ENGINEERING CHANGE ORDER

NEXT ASSY.	USED ON	 Processor Technology Corporation 6200 Hollis Street Emeryville, CA 94608	DRAWN: A. ATARIAN II	ENGR: R. Mann
ECO 10018	105009		DATE: 2/9/77	DATE: 2-10-77
			CHECKED: K. Jorgensen	RELEASED: R. Mann
			DATE: 2/9/77	DATE: 2-10-77
		MODIFICATION, PC BOARD, Sol Reg, CROW BAR		
		REF. DRAWING NO. 100510		
B	E.C.O. 10017	SCALE: —		
REV.	DRAWING NO.	SHEET 1 OF 1		SIZE

BOTTOM VIEW (Solder Side)

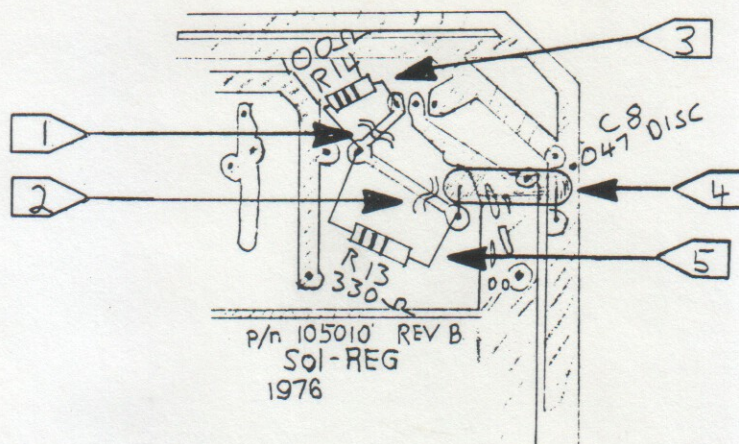
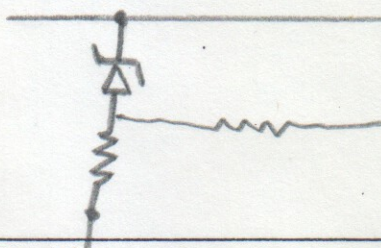
- 1) CUT TRACE CONNECTING Anode of D1 with gate of SCR1.
- 2) CUT TRACE CONNECTING R2 WITH D1.
- 3) Solder R14 (new) TO pads of D1 ANODE + SCR1 GATE.
- 4) SOLDER C8 (new) TO pads of R2 (both ENDS).
- 5) Solder R13 (new) TO pads of D1 (ANODE) + R2.

R14	NEW	100Ω 5% 1/4W	Film Resistor	1					
R13	NEW	330Ω 5% 1/4W	Film Resistor	1					
C8	NEW	.047UF	DISC CAPACITOR	1					
REF. DES.	PART OR DWG. NO.	PART DESCRIPTION
